# E4093A/B-02-S

## S E R V I C E N O T E

### HP E4093A/B PT500 Protocol Tester

### PT BACK BEZEL GROUNDING WIRES UPGRADE

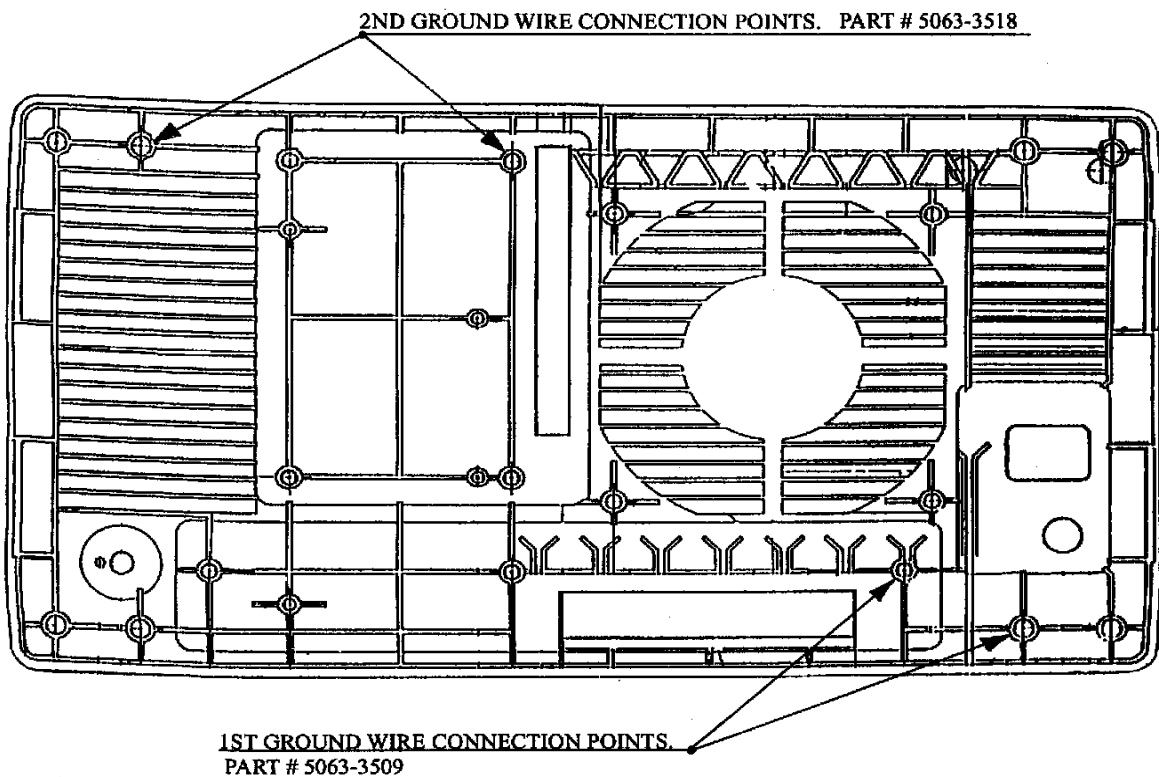
A situation exists in which a unit in the referenced serial number range could possibly become a shock hazard to personnel. This situation would likely only occur if high voltage is present on the connector module plane or connector module handle and the existing ground path was blown away. The existing ground path is insufficient to carry current specified by Hewlett-Packard safety requirements. This situation has occurred to date only when checking the unit with a megger or similar device.

- Remove top cover of instrument and interface module.
- Install longer (11 cm) ground cable, p/n 5063-3518, to existing screw of upper left hand side member bracket hole.
- Connect to inside connector module hole, beside degaussing board, with 4x5 screw.

- Remove bottom cover of instrument and auxilliary connector module.
- Install 8 cm ground cable, p/n 5063-3509, to right hand side hole of auxilliary connector with 4x5 screw.

- Connector module handle should be grounded from the rear handle screw to the nearest DB style connector screw by installing one of the 5063-3510 wires between these two points.
- Use the four 4x28 screws to reinstall connector module.

- Applies only to MPT368.2, IPT468, XPE systems with no parallel printer connector, that is, with auxilliary connector module 4010-0070-IDA.
- Install grounding wire between the handle mounting screw and the nearest screw of the "PRINTER" connector.
- Reinstall auxilliary connector module using three 4x25 screws.

Affected units must be retrofitted with grounding wires to rectify the problem, using the following instructions.
